**MACEDONIA PLANNING COMMISSION
MEETING AGENDA
APRIL 21, 2025**

Re: Plan Review Comments: 9764 Valley View Road lot consolidation plat

SUBJECT: Final Plan Approval - Specialty Lubricants Building Addition & Site Improvements

EXTERIOR ELEVATIONS
DRAWING NO:

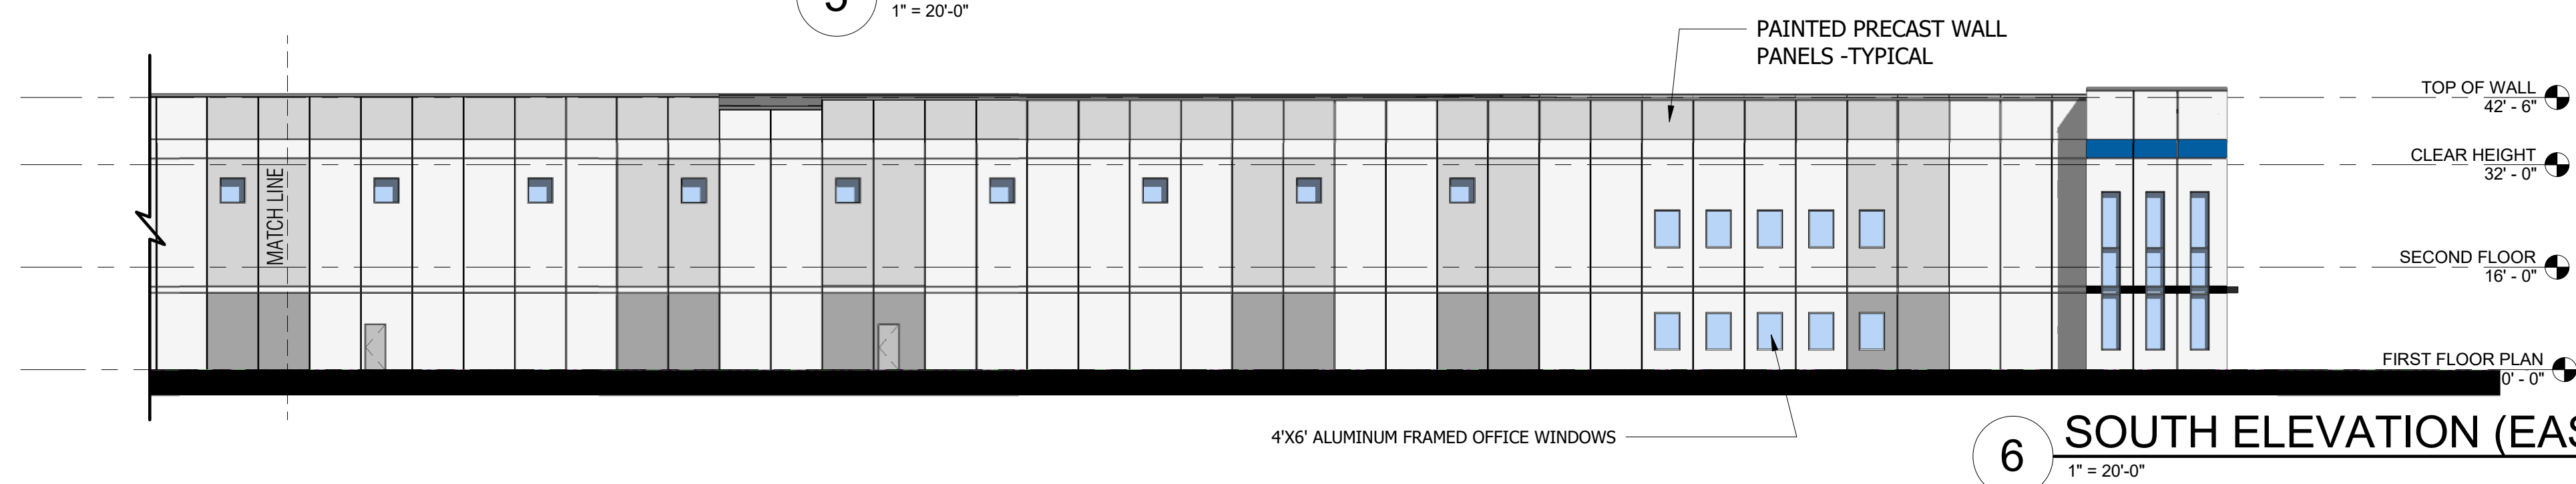
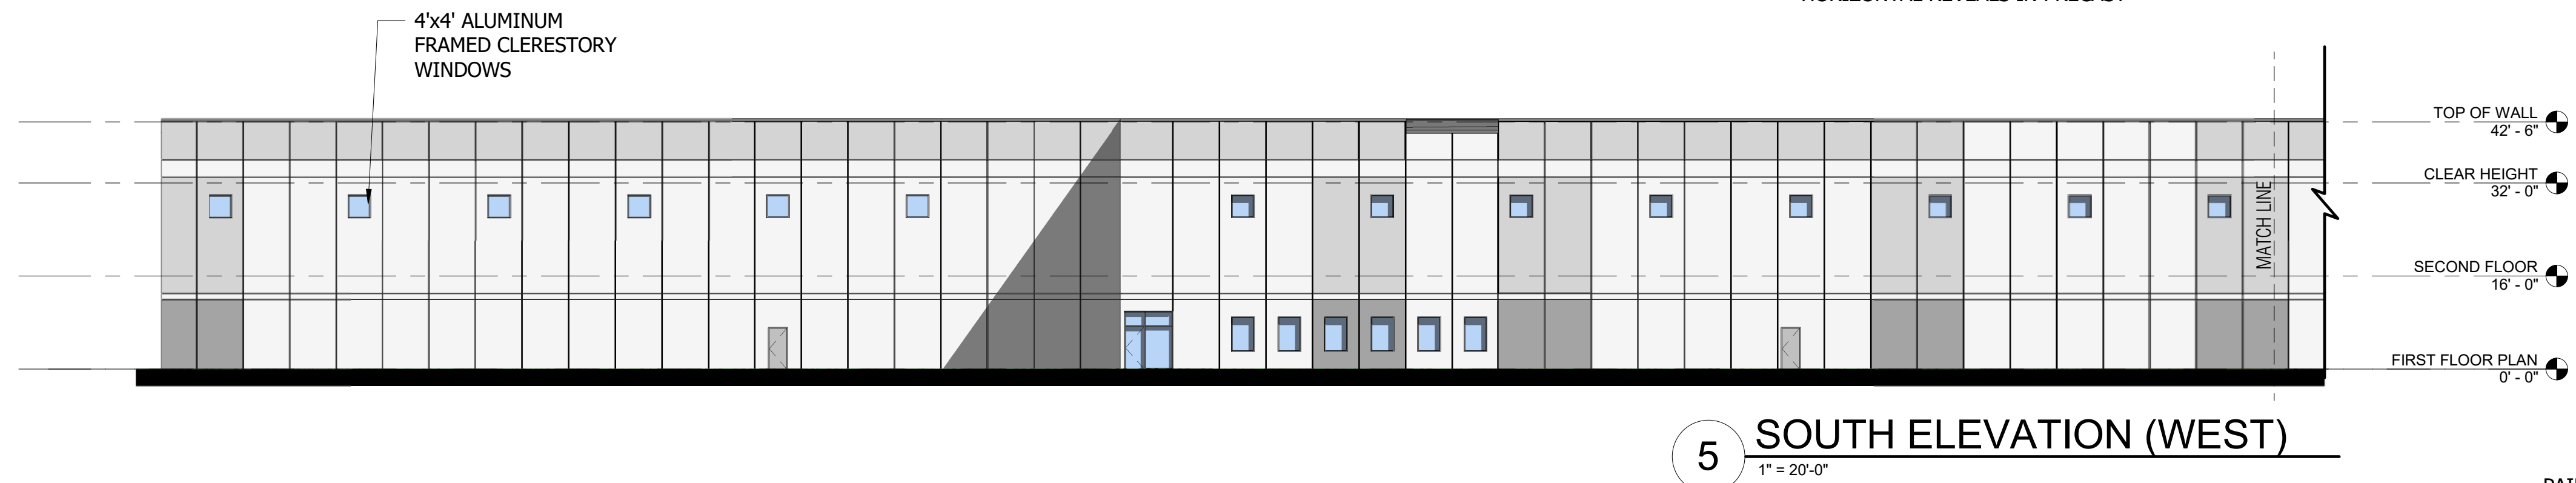
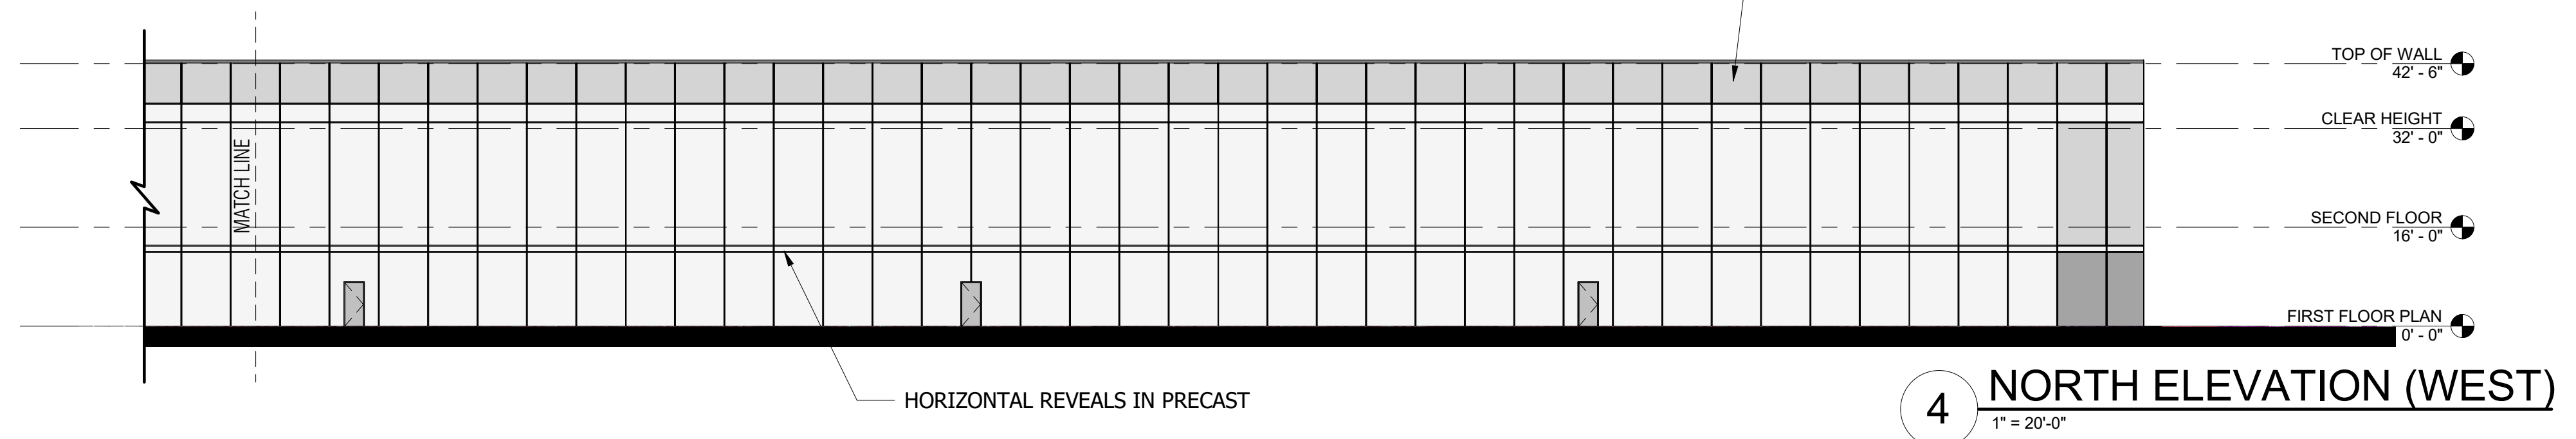
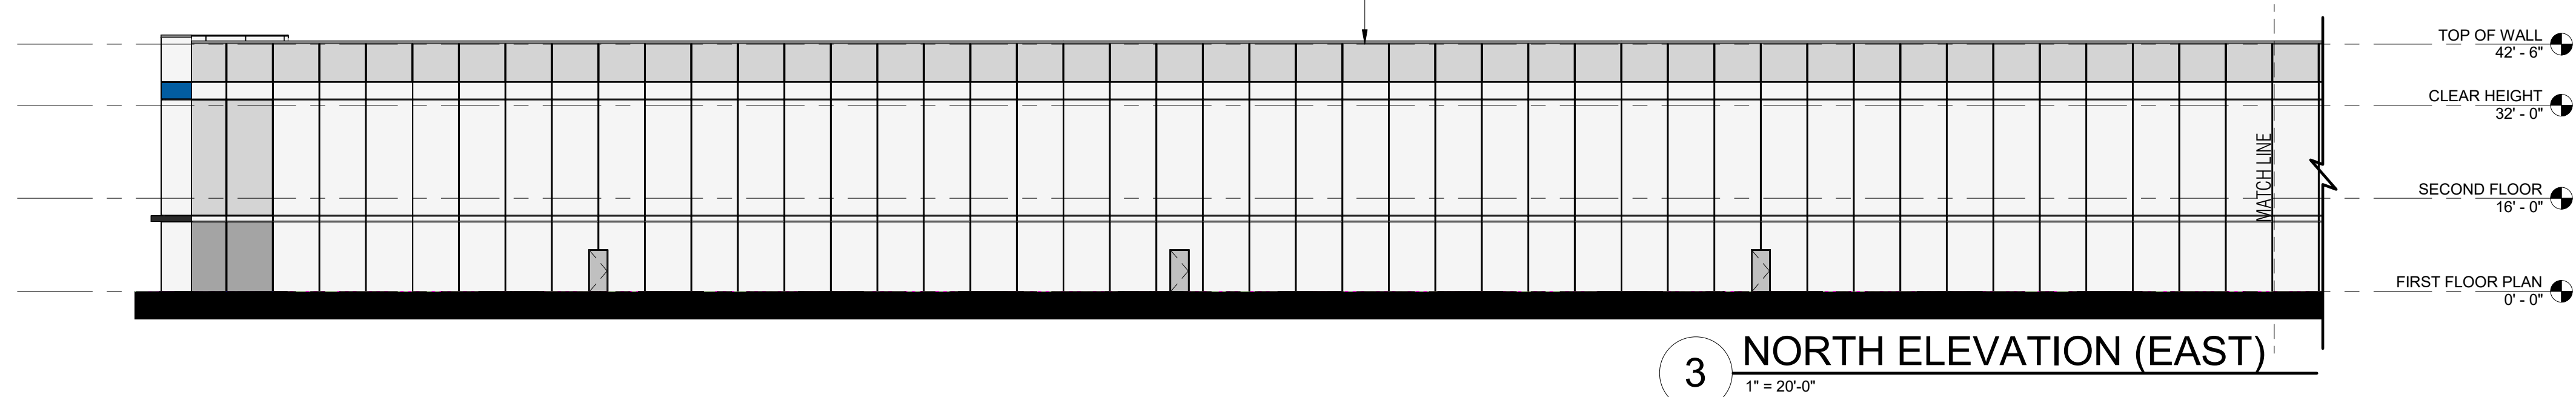
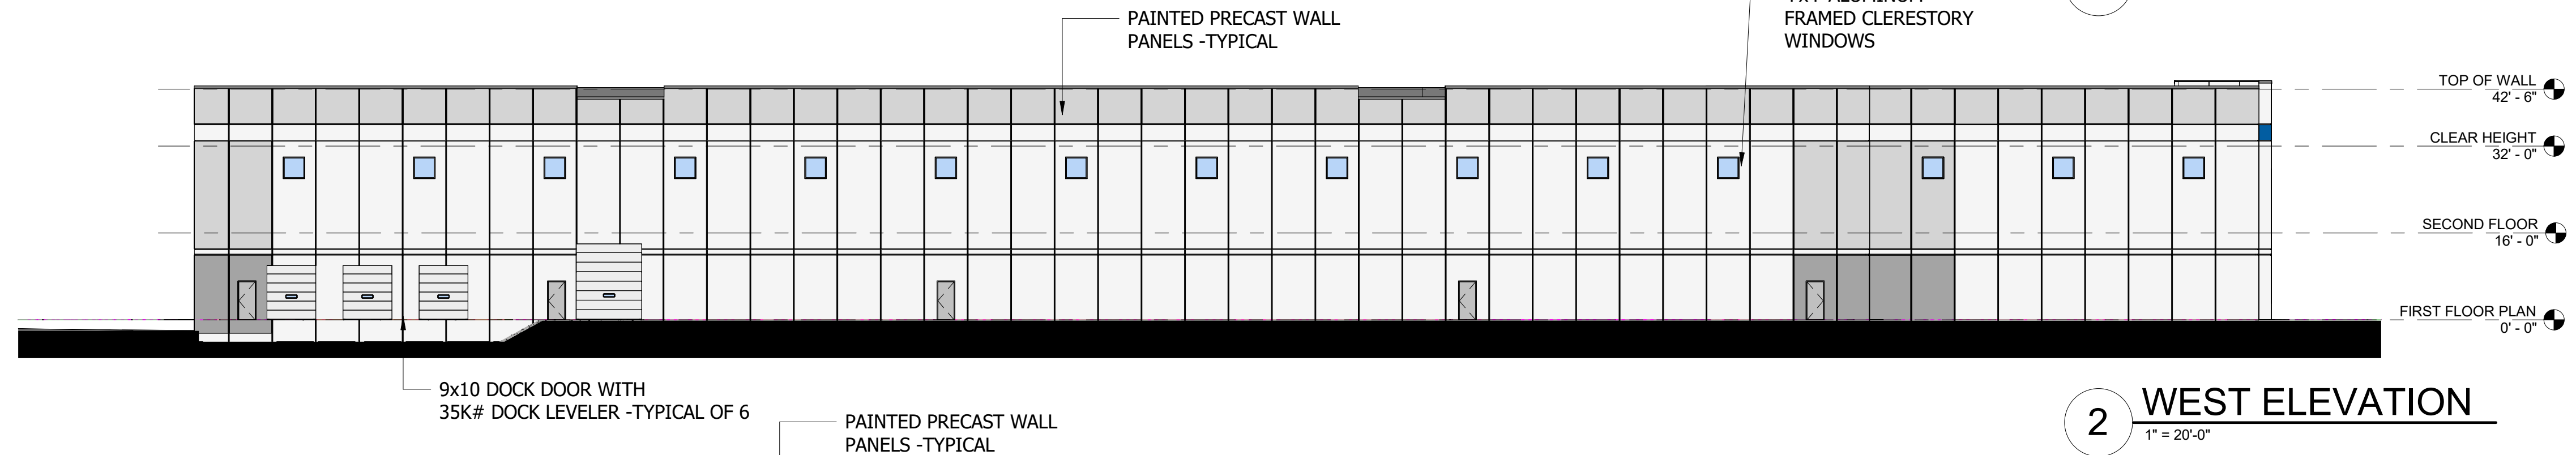
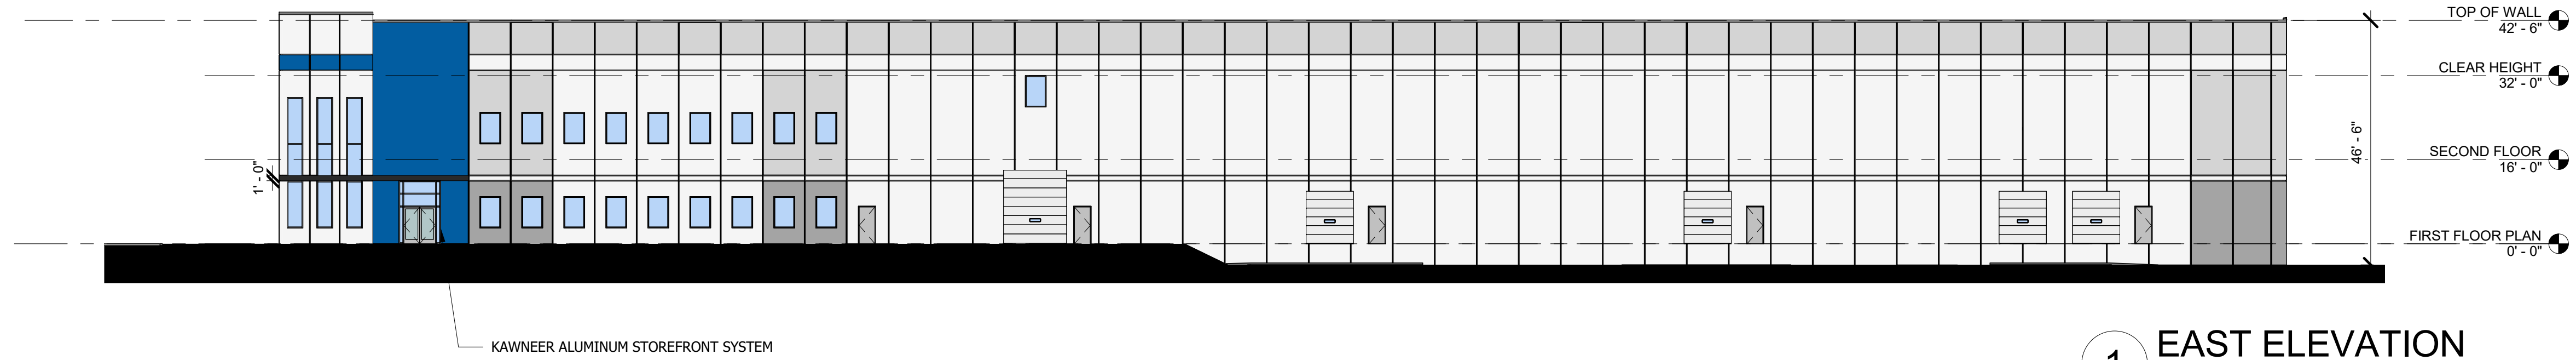
- 8) Building architecture is documented on Sheet A-301 and proposes a precast wall panel style of construction. **ACTION ITEM: The building architecture is subject to the standards outlined in Section 1172 of the Code. The City's Design Consultant should review the project for compliance with the applicable Code provisions.**

PP.1

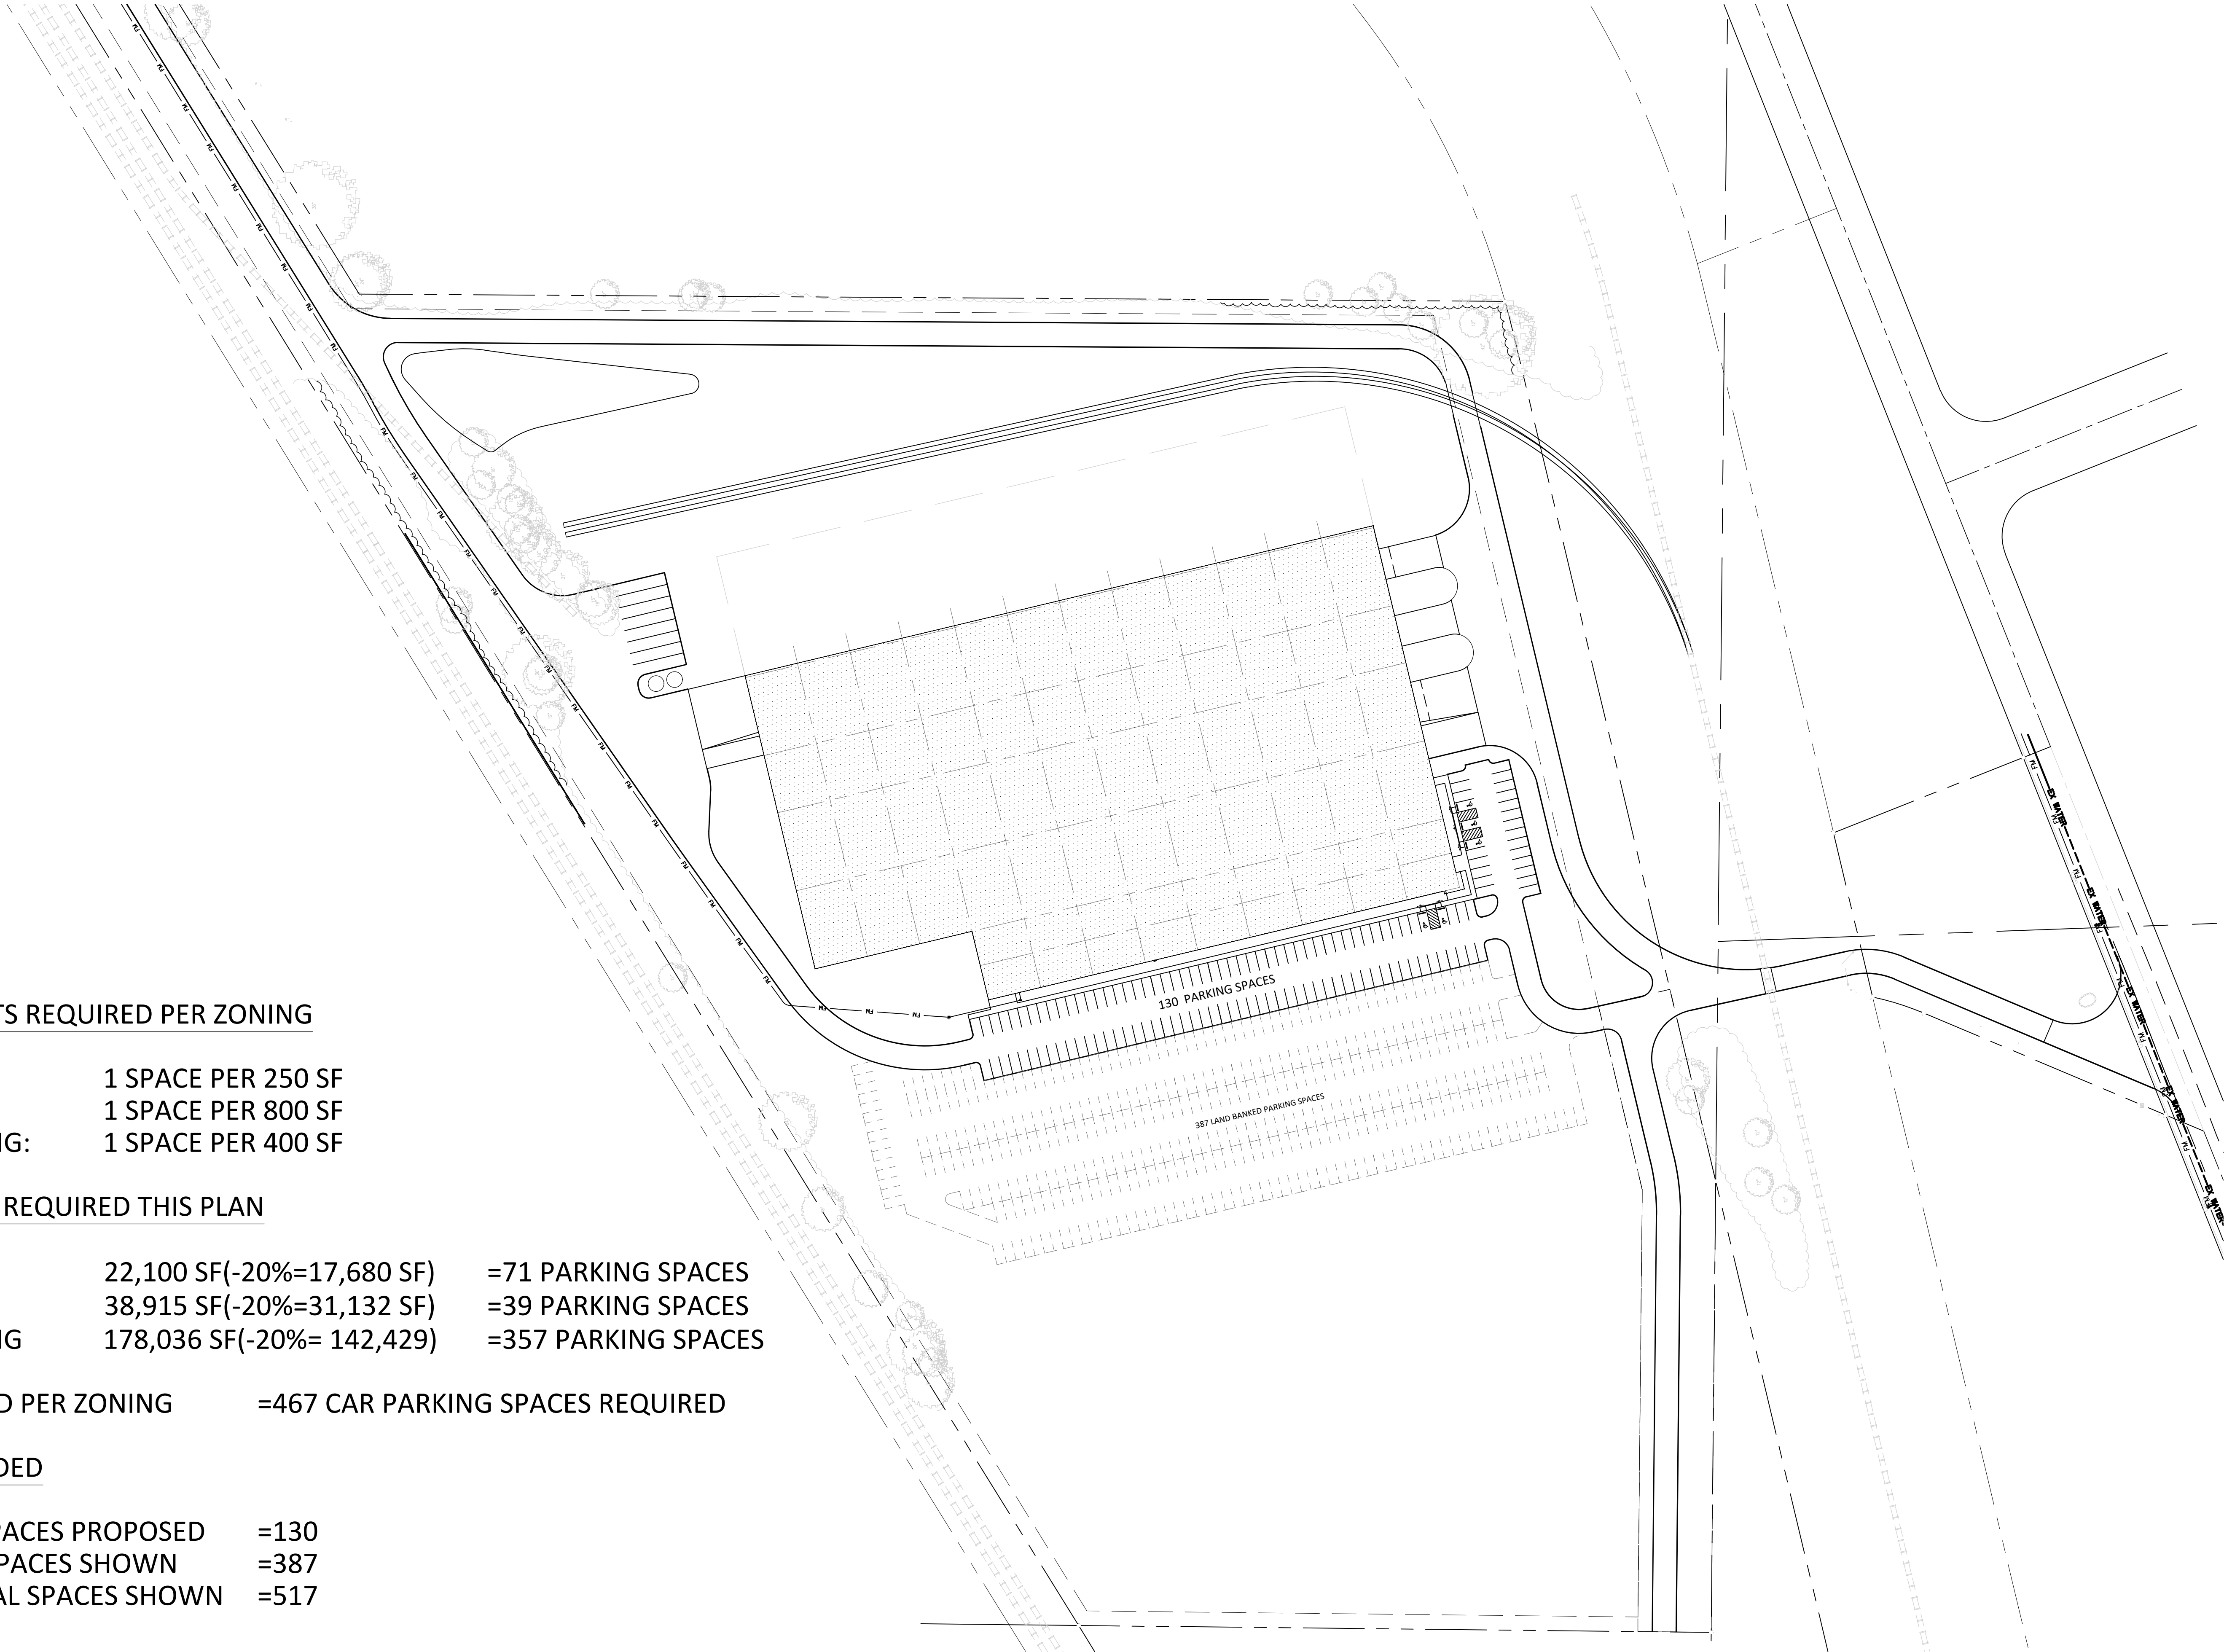
- 3) The legend on site plan states that 129 off-street parking spaces (previously 132) are provided, and the building is proposed to be 238,920 square feet. Sheet PP.1 provides an analysis of parking counts and states that 130 spaces are proposed. Section 1171.11 (b) (2) provides for a 20% reduction. Therefore, parking is based on the following:

- d) The total required off-street parking based on the above break-down is 467. This means the site is deficient by 338 parking spaces if 129 spaces are provided. Sheet PP.1 proposes 387 land-banked parking spaces. However, the Planning Commission doesn't have the ability to waive the parking standard and permit land-banking.
ACTION ITEM: A variance from the Board of Zoning Appeals (BZA) is needed for the reduction and the minor discrepancy between Sheet PP.1 and C102 must be corrected.
